Access Compliance Report

Public Rights-of-Way

(Curb Ramps)

Intersection ID: 53157	Main Street: DALLAS_BAY_RD	Cross Street: HAMILTON_BRIDGE_RD	Location: SW
ADA ID: 80823C4FD4CA	Ramp Type: BlendTrans2	Initial Pass/Fail: Fail	Overall Compliance: No
		Severity Score: 8.75

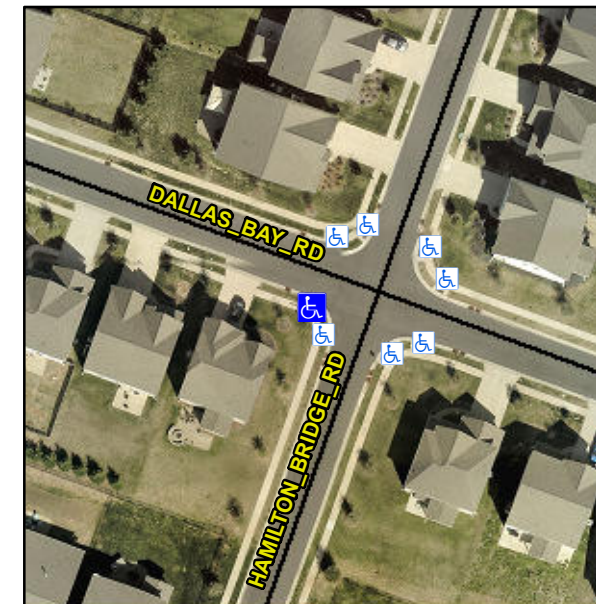
Not Found, R304.5.1

Remove & Replace Curb Ramp With Two New Directional Ramps or Equivalent.
